Agenda Item: 7.2
Source: Ericsson
Title: UE Receiver Blocking Frequency Bands
Document for: Approval

This document suggests a change in S4.01A v0.0.3 UTRA (UE) FDD Radio Transmission and Reception [1], Ch. 7 Receiver Characteristics, Ch.7.6 Blocking Characteristics, 7.6.1 minimum requirements.

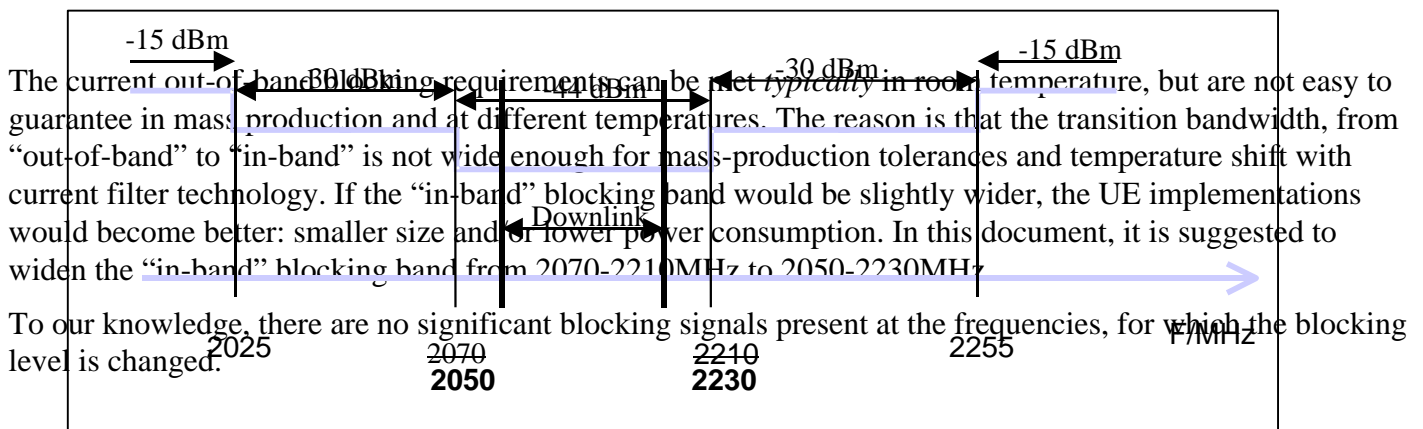
The scope of this document is to suggest a change, which eases the implementation requirements of the UE receiver.

It is common to have a filter prior to down conversion, which in principle reduces the level of the out-of-band blocking signals to the level of the in-band blocking signals. The advantage with this principle is that after filtering, the receiver selectivity and dynamic range is dimensioned of the in-band blocking level only. Hence, the out-of-band blocking requirements should only affect the LNA linearity requirements.

Currently, the level of the in-band blocking signal is -44dBm . Next to the “in-band” blocking band are the “band 1” out-of-band blocking bands, 2025-2070MHz and 2210-2255MHz. The blocking level in the band 1-bands is -30dBm .

The proposal is a change in ch. 7.6.1 of S4.01A v0.0.3 UTRA (UE) FDD Radio Transmission and Reception, Table 11:

From: Blocking offset, band 1, 2025<f<2070, 2210<f<2255

To: Blocking offset, band 1, 2025<f<2050, 2230<f<2255
